PROJECT: DAVID STREET STATION
200 SOUTH DAVID STREET
CASPER, WYOMING 82601

ADDENDUM NUMBER TWO

This addendum number one dated Thursday September 8, 2016 is hereby appended to and became a part of the Contract Documents for the David Street Station, 200 South David Street, Casper, Wyoming. Drawings and specifications dated May 10th, 2016.

PARTIAL SHEET 2.13

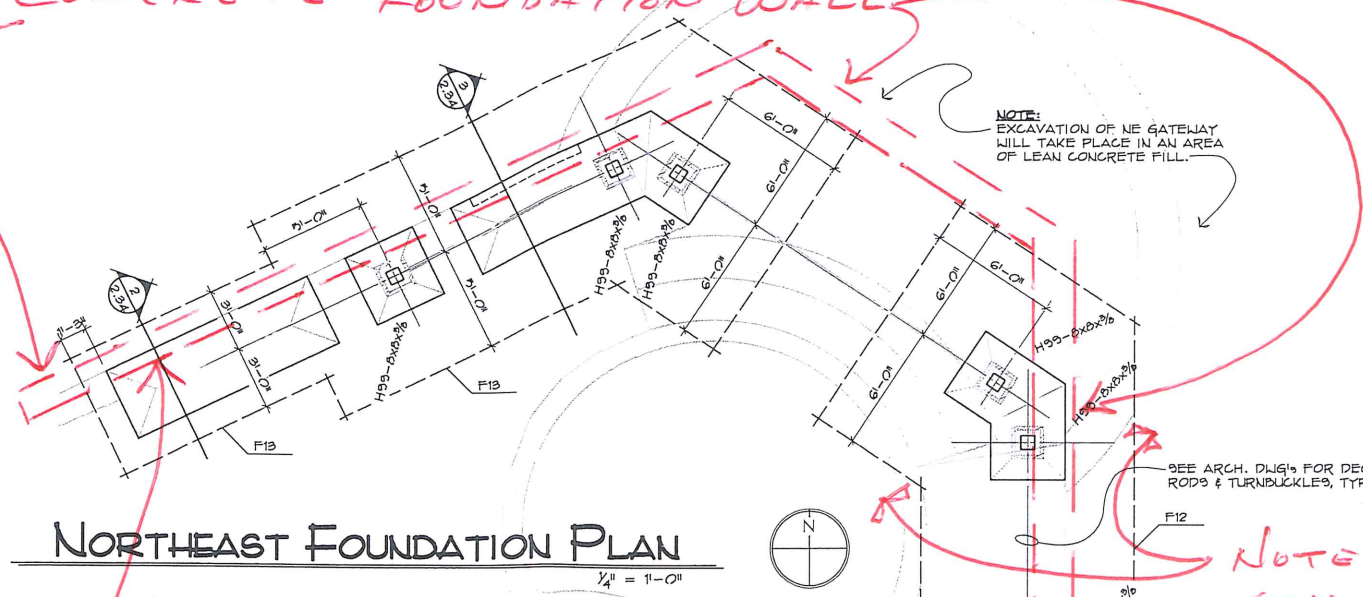
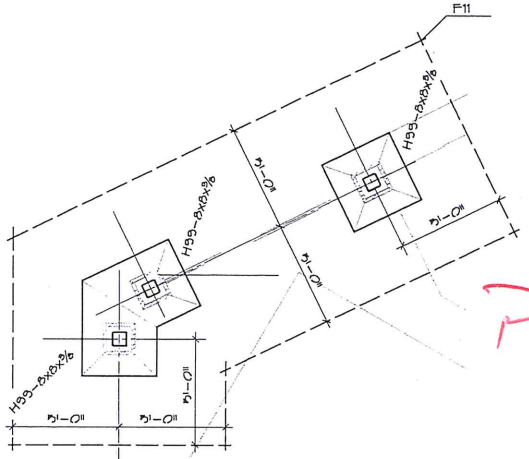
CHANGE: GATEWAY FOUNDATION PLANS: At the northeast gateway it has been determined that the subgrade is not lean concrete as previously thought. The in place soils are sands. However an existing 16" thick foundation wall exists as shown on the attached partial sheet 2.13 that must be partially removed per the attached plan. This wall is unreinforced concrete. The in place sands must be sub-excavated 2'-0" below footing subgrade, moisture conditioned and re-compacted to 95% ASTM D698 density.

DEMOLISH EXISTING CONCRETE WALL TO FOOTING SUBGRADE ELEVATION.

NOTE: IN PLACE SOILS THIS AREA ARE SANDS. FOOTING SUBGRADE THIS AREA MUST BE SUB-EXCAVATED 2'-0" MOISTURE CONDITIONED & RECOMPACTED TO 95% ASTM D698.
